Addendum #2

T2 R9 Training Site Development Project Phase I

Project No. 23TC20-508 Bid Number # 20-041

1 June 2020

T2 R9 TRAINING SITE OPERATIONS BUILDING

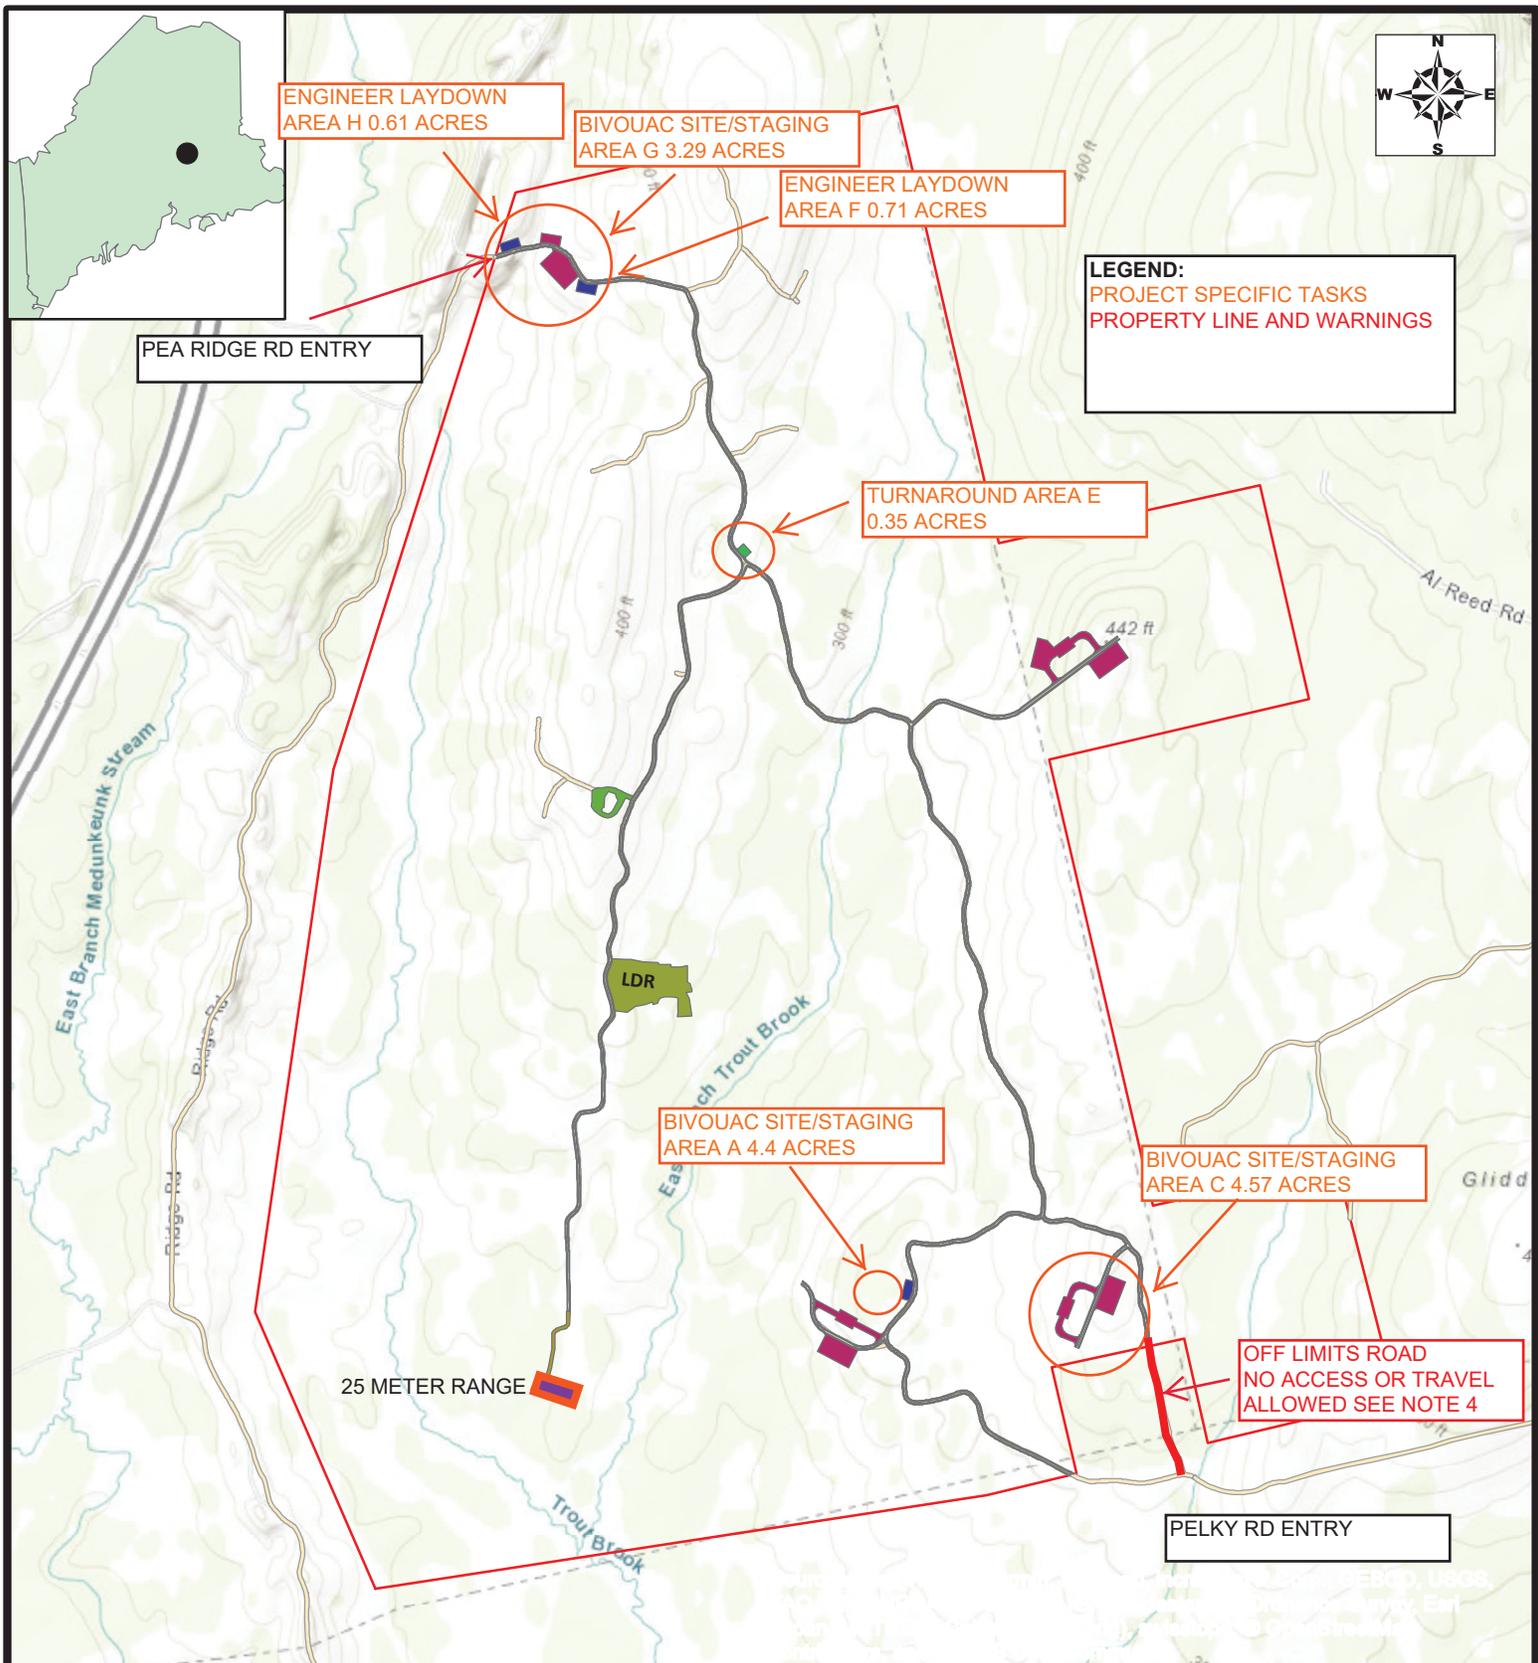
3. **Remove** Map. Appendix 3 T2 R9 Training Site Operations Building and **insert** attached Map. Appendix 3 T2 R9 Training Site Operations Building. Change is location of facility and the elimination of the tree clearing requirement. New site is in existing clearing. See Memorandum From Site Visit, 28 May 2020 for more details.

1. I moved the location of this facility during this site visit due to common sense. During the visit in the general vicinity of where we were going to place it I discovered a clearing directly adjacent to the existing road that was cleared of vegetation and relatively flat and dry. It made perfect sense to place the facility at this location and Training Sites concurred with my assessment. This eliminates any tree clearing requirement to get access to this site as well. The location has been updated in Addendum 2.
2. The facility is no longer part of Area A.

T2 R9 DEVELOPMENT TREE CLEARING FOR PHASE II

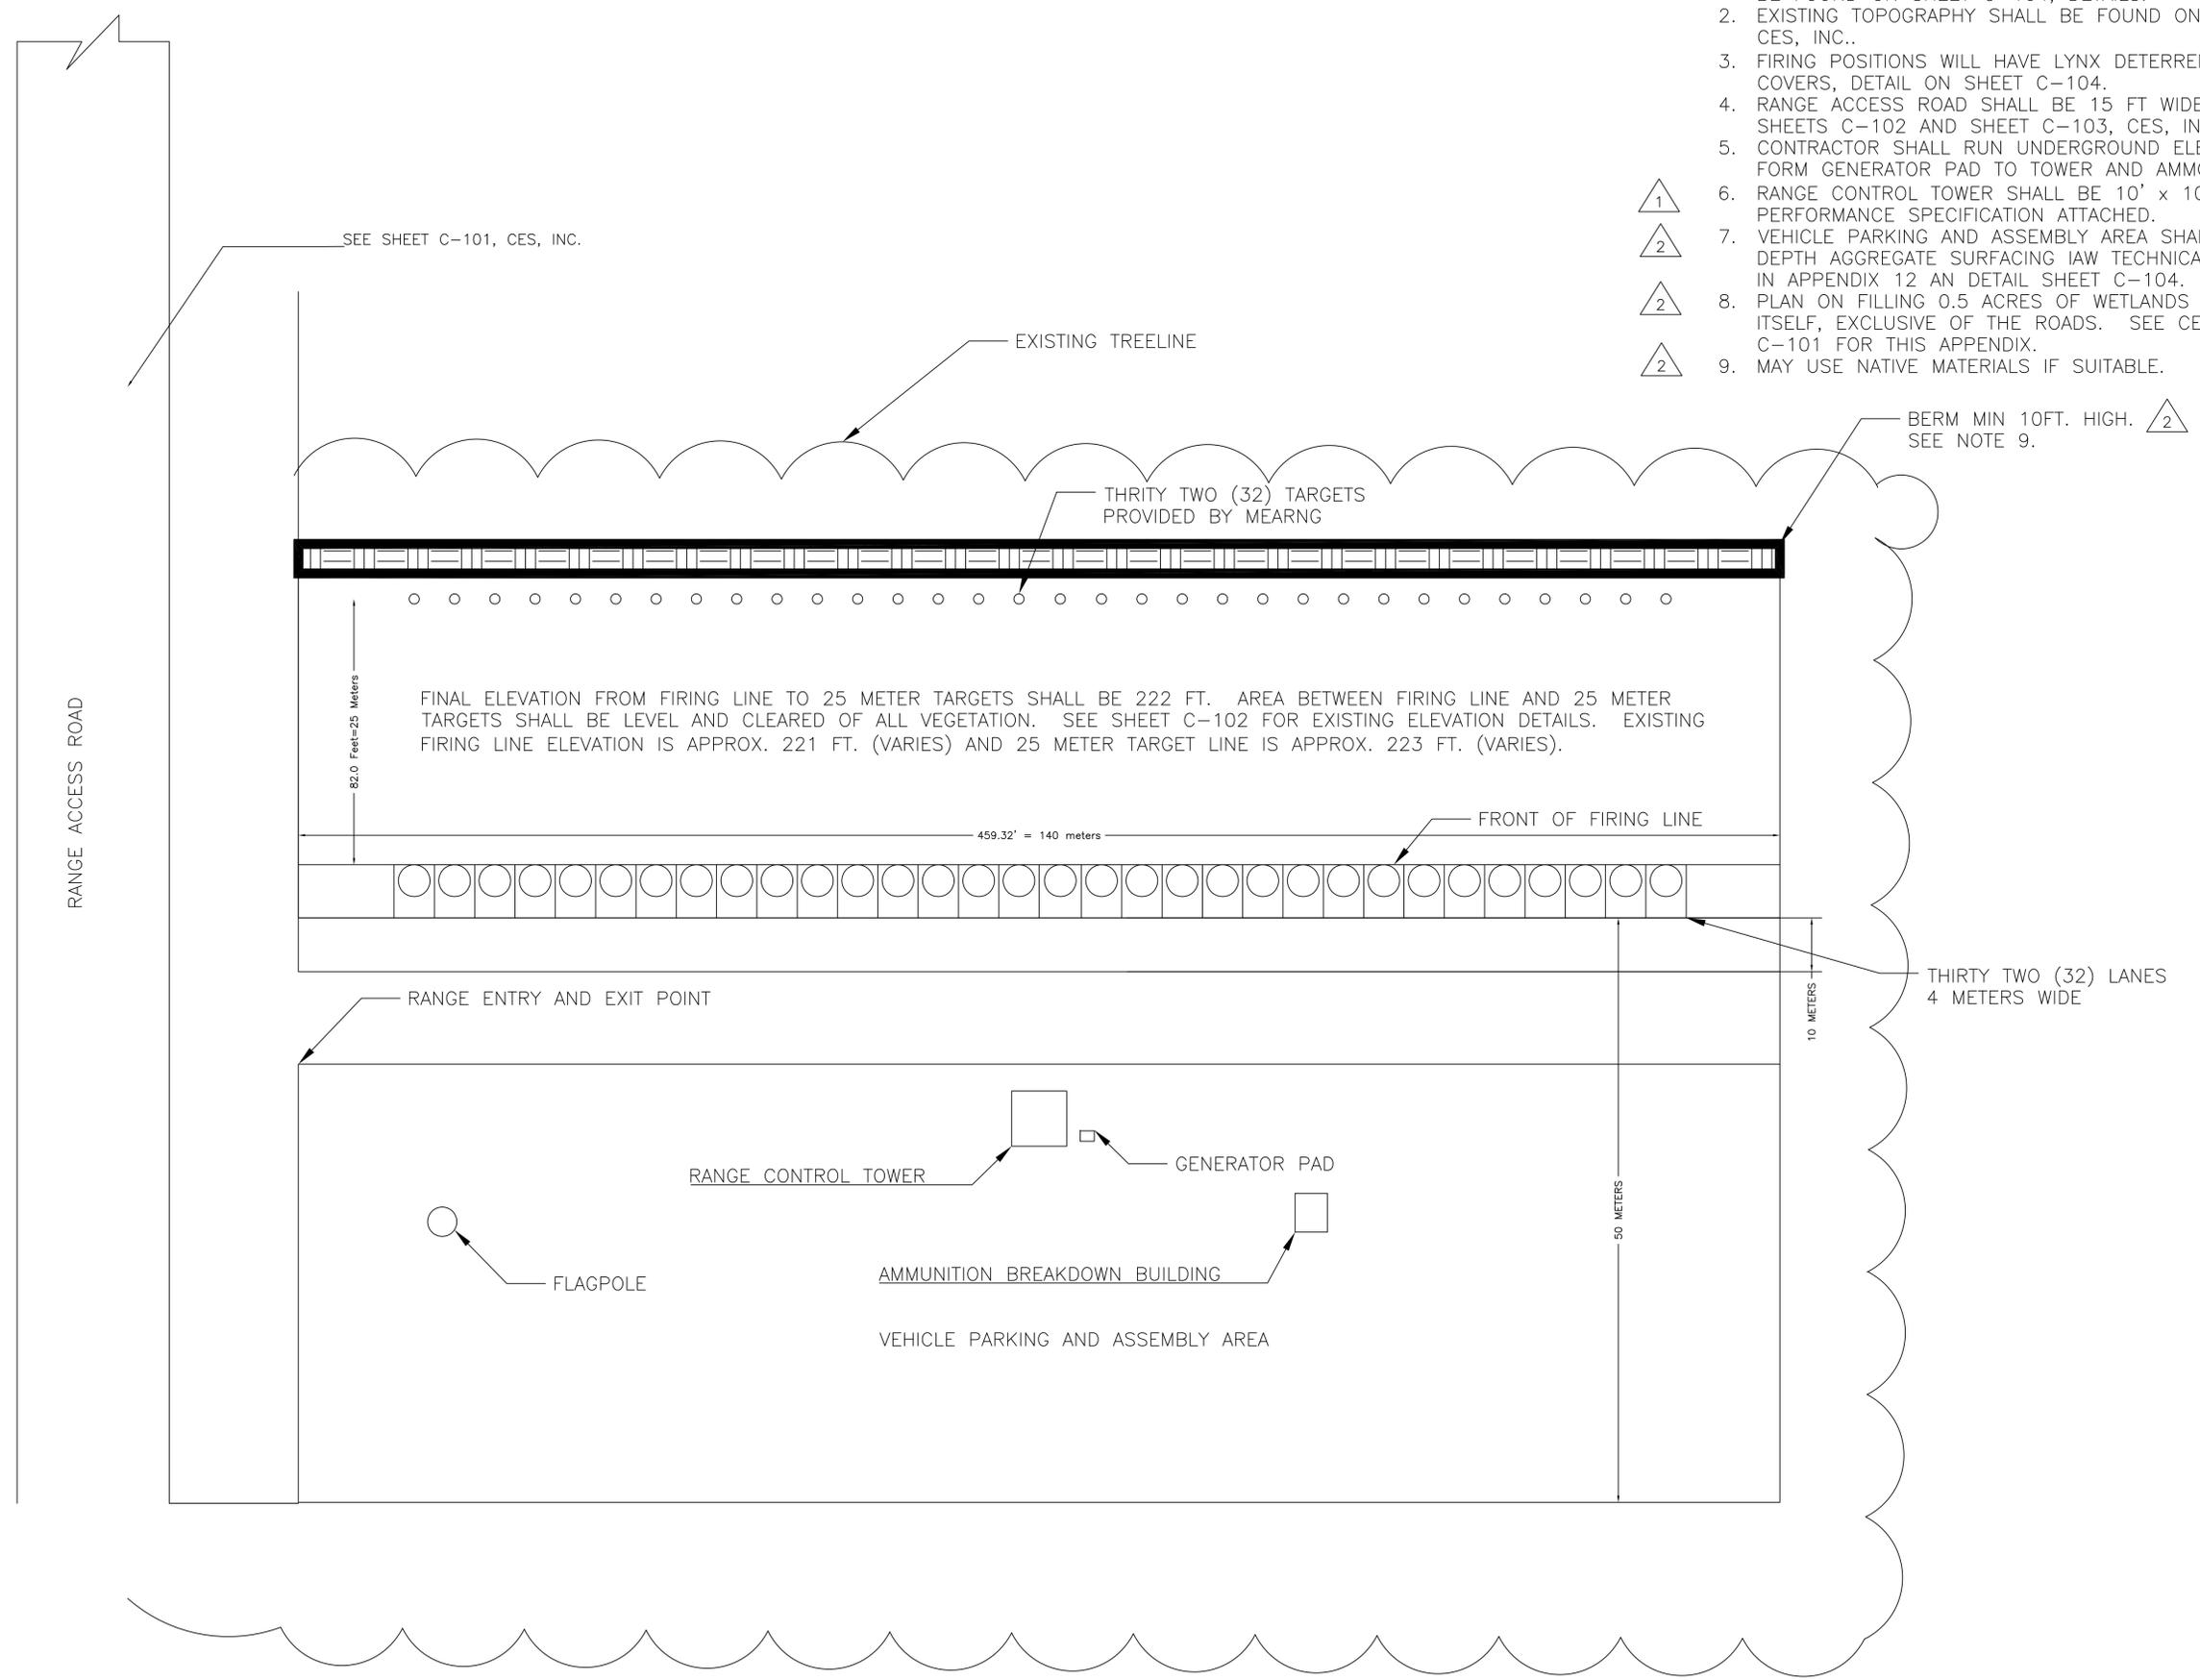
5. **Remove** Map Appendix 11, T2 R9 Development Tree Clearing for Phase II, and **insert** attached Map Appendix 11, T2 R9 Development Tree Clearing for Phase II. See Memorandum From Site Visit, 28 May 2020 for details. Site A has been moved slightly North than originally depicted.

1. The layout for this site provided in the bid documents is accurate. Except we actually moved the location slightly north closer to Laydown Area B due to the steep elevations encountered by the AE at the original location. I have indicated the new location in Addendum 2 and the Training Site Operations Building is no longer collocated with this facility.
